Memorandum

DOCKET	
08-AFC-7	
DATE	<u>NOV 23 2009</u>
REC'D	<u>NOV 23 2009</u>

Subject: **STAFF'S ERRATA TO THE FSA**

At the November 17, 2009 Pre-Hearing Conference, staff and applicant agreed on several changes and corrections to the Final Staff Assessment. At the request of the Hearing Advisor, staff is submitting the following errata to the FSA:

VISUAL RESOURCES FIGURE 9
GWF Tracy Combined Cycle Power Plant Project - Intervenor's Property Locations

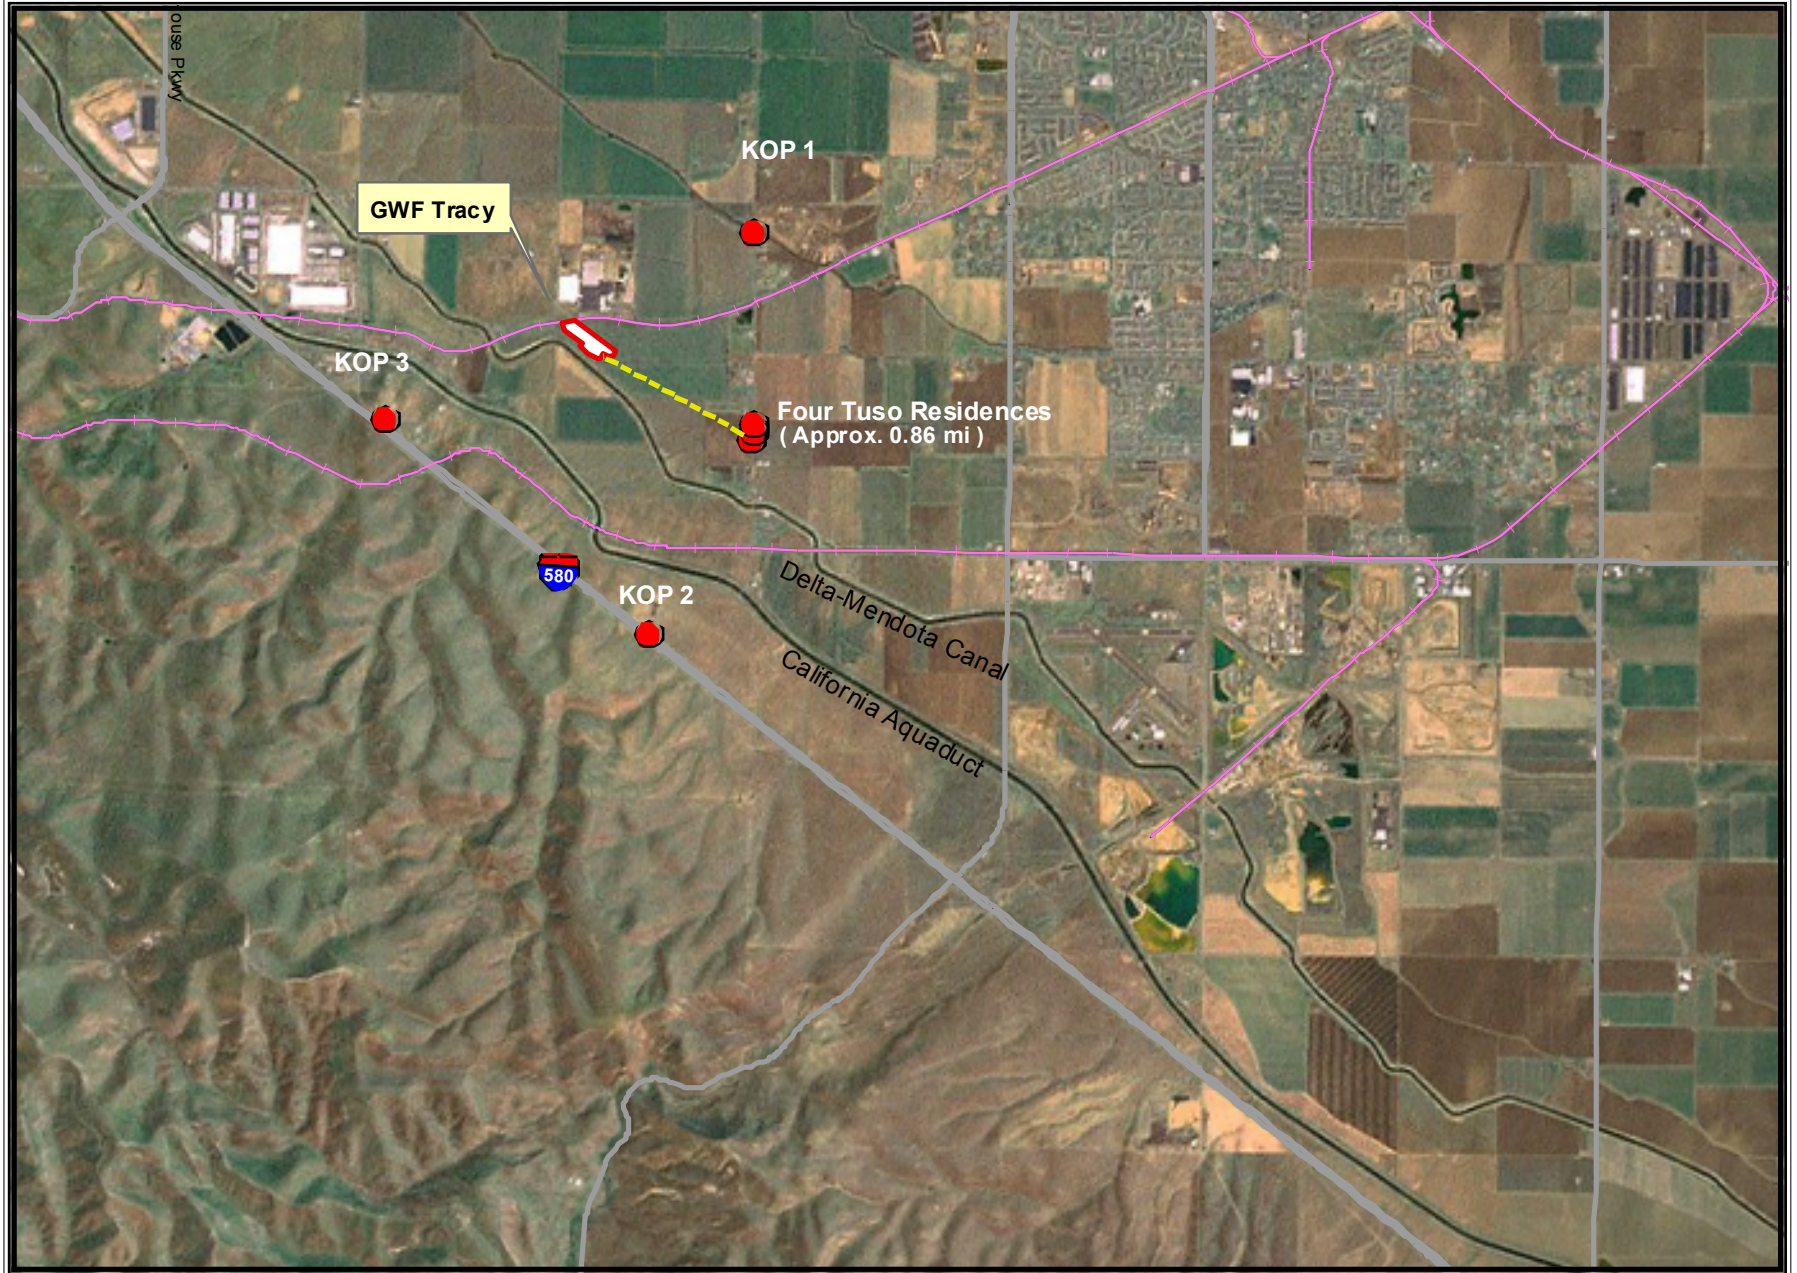
- Visual Resources Figure 9, GWF Tracy Combined Cycle Power Plant Project—Intervenors' Property Locations.

Replace with revised Visual Resources Figure 9 (Attached.)
